**CONSULTATION RESPONSE TO
PLANNING OR RELATED APPLICATION**

Comments provided by	Roads Planning Service	
Officer Name, Post and Contact Details	Alan Scott Senior Roads Planning Officer	ascott@scotborders.gov.uk 01835 826640
Date of reply	19 th February 2020	Consultee reference:
Planning Application Reference	18/01777/FUL (Appeal Ref. 19/00029/REF)	Case Officer: Carlos Clarke
Applicant	Mr. C. Dougall	
Agent	Suzanne McIntosh Planning Limited	
Proposed Development	Erection of two dwellings	
Site Location	Garden ground of 7 Heriot House	
<i>The following observations represent the comments of the consultee on the submitted application as they relate to the area of expertise of that consultee. A decision on the application can only be made after consideration of all relevant information, consultations and material considerations.</i>		
Background and Site description		
Key Issues (Bullet points)		
Assessment	<p>It is my opinion that the additional information has still not addressed the concerns previously raised and does not address the concerns of reason 2 for refusal.</p> <p>When you look at the elevations drawings for house 1 (Drg. No. 17-40-003 Rev G), Elevation 1 shows the post

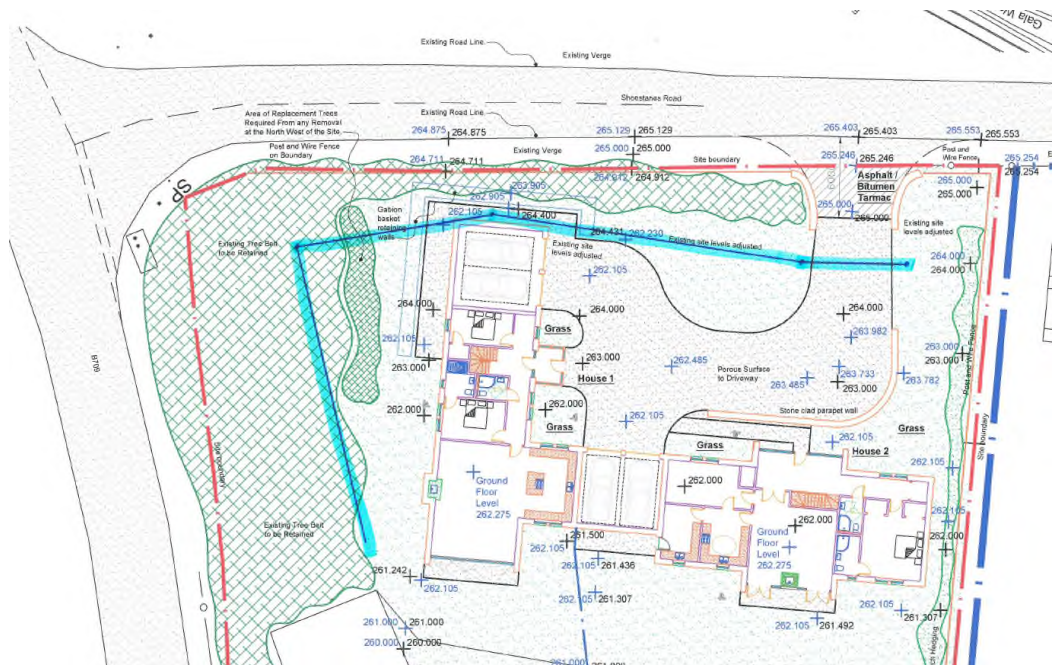
submission of further drawings which accurately show the existing layout and the proposed layout, with appropriate sections and engineering details for the gabions. Confirmation would also have to be obtained as to whether any formal process would be required to amend the boundary currently being considered as part of the adoption process for roads associated with the reinstatement of the Border Railway (eg Stopping-up orders).

The snip below shows in green what I believe to be the line of the existing fence.

As the applicant has not shown that they can provide the development without a significant impact on the public road, I am still unable to support the proposal.
